ITEM 7
MANAGER'S REPORT NO. 43
COUNCIL MEETING June 10/74

Re: Watercourse Retention
Subdivision Reference #24/74
D.L. 92, Lot 83, Plan 1146

TO: MUNICIPAL MANAGER
FROM: APPROVING OFFICER
RE: NATURAL WATERCOURSE
SUBDIVISION REFERENCE #24/74
D.L.92, LOT 83, PLAN 1146

LOT 83
 D.L. 92
 PLAN 1146

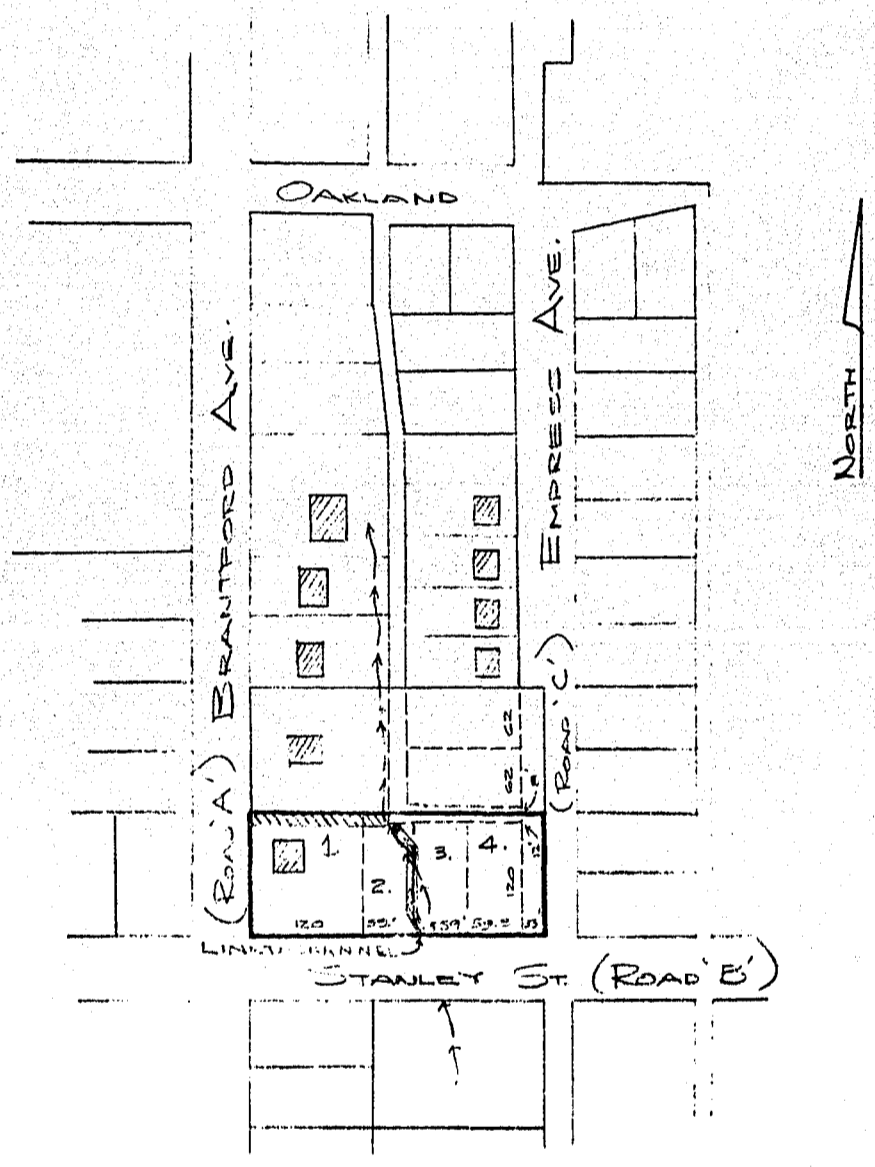
Note: ① REQUIRE SURVEYOR'S PLOT PLAN OF HOUSE.
 ② CREEK IS IN AN OPEN NATURAL CONDITION NORTH OF THE PROPOSED SUBDIVISION.

Note: ③ CREEK IS TO BE LEFT IN AN OPEN CONDITION BUT MUST BE REALIGNED ON THE BOUNDARY OF LOTS 2 & 3 FOR A DISTANCE OF 30 FT. THE CREEK MAY THEN CUT ACROSS THE BACK OF LOT 2. THE ENGINEERING DWGS MUST MAKE ADEQUATE PROVISION FOR THE CONTAINMENT OF THE CREEK.
